# **A Clean Energy Future for Xcel: Response to Xcel's Alternate Plan**

**October 2021**

## 1 Xcel's Alternate Plan

**Figure 1. CEO Alternate Plan Capacity Expansion Plan (2020 – 2034)<sup>6</sup>**

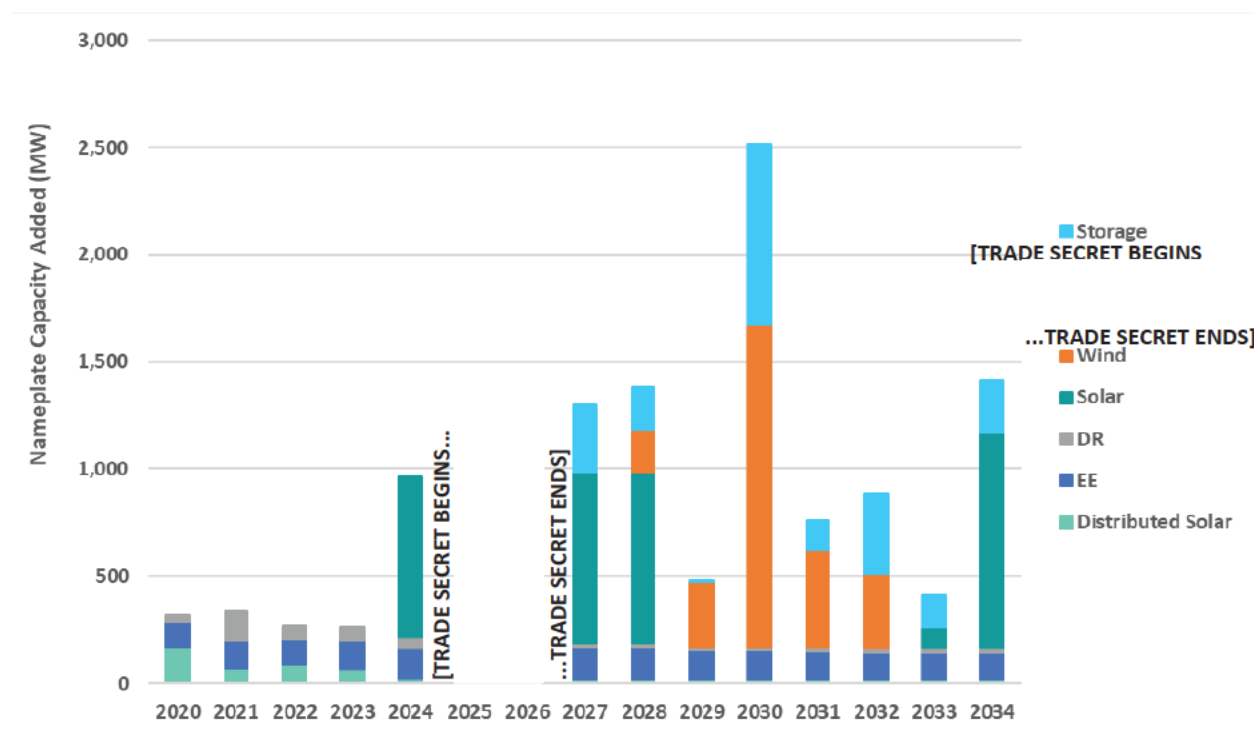
Figure 1 shows the capacity expansion plan for the CEO Alternate Plan, which contains no new natural gas resources outside of the repowering assumptions Xcel made in its Alternate Plan. The CEOs' Alternate Plan contains a mix of solar-battery hybrid resources, wind, and standalone storage resources across the Sherco, King, and NSP "areas" modeled in EnCompass.

The CEOs' Alternate Plan, which includes the addition of solar hybrid resources and revised battery cost and operating life assumptions, does not result in the selection of the Fargo and Lyon County CTs. The CEOs' modeling indicates that the model is optimally selecting a mix of solar-battery hybrid, solar, wind, and standalone battery storage resources. Table 7 shows that between 2027 and 2029, the CEO Alternate Plan adds 450 MWs of solar hybrid resources, 116 MWs of standalone battery resources, 400

MW of hybrid battery storage, and 100 MW of wind over and above the capacity of those same types that is in Xcel's Alternate Plan. The CEO Alternate Plan does not include the 800 MW of CT capacity that is included in Xcel's Alternate Plan. Given the economic nature of these resources, it is crucial for Xcel to fully explore the ability of solar-battery hybrid and standalone battery storage resources to provide critical grid services.

Figure 2. Weighted Average Capacity Factor (%) of Xcel's CTs During Arctic Event<sup>10</sup>

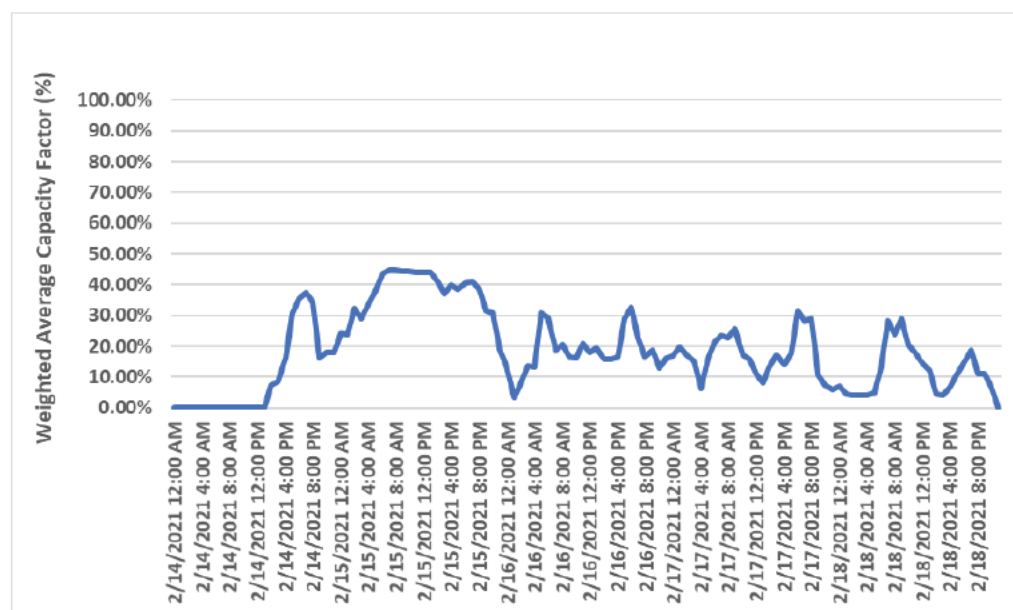
In the Supplemental Report, Xcel discusses the need for firm, dispatchable resources to be able to operate during periods of extreme weather. Xcel points to the 2019 Polar Vortex and the 2021 Winter Storm Uri (what MISO calls the February Arctic Event) as examples of recent extreme weather events and points to the firm resources on Xcel's system that operated during those events, like the nuclear and CT capacity. Figure 2 shows the hourly weighted average capacity factor of Xcel's existing CTs during the 2021 February Arctic Event, which started on February 14<sup>th</sup> and ended on February 18<sup>th</sup>. During this event, six of the CTs did not operate during any hour of the Arctic Event. We are not sure if the units did not operate because of fuel supply interruptions (gas generators throughout ERCOT, SPP, and MISO had difficulty procuring gas) or if there was another reason these units were offline. The weighted average capacity factor suggests that, absent fuel supply constraints, Xcel's existing CT fleet still had capacity to operate at higher levels during this Arctic Event.

Even if fuel supply were not an issue for Xcel, there no indication that the existing fleet could not operate at higher capacity factors during extreme events. Certainly, these data do not support the notion that new CTs must be added in 2027 and 2029 for reliability reasons. In its Supplemental Report, Xcel states, “As we continue to retire coal and add renewables, our modeling continues to show the need for some firm, dispatchable resources.”<sup>11</sup>

Our plan retains the same level of CT capacity as is in Xcel’s Alternate Plan and again that capacity did not operate at even close to its full capability during the Arctic Event. We are not suggesting that Xcel rely exclusively on 4-hour battery storage to cover these contingencies, far from it. The point here is that Xcel already has a large CT fleet, [TRADE SECRET BEGINS...
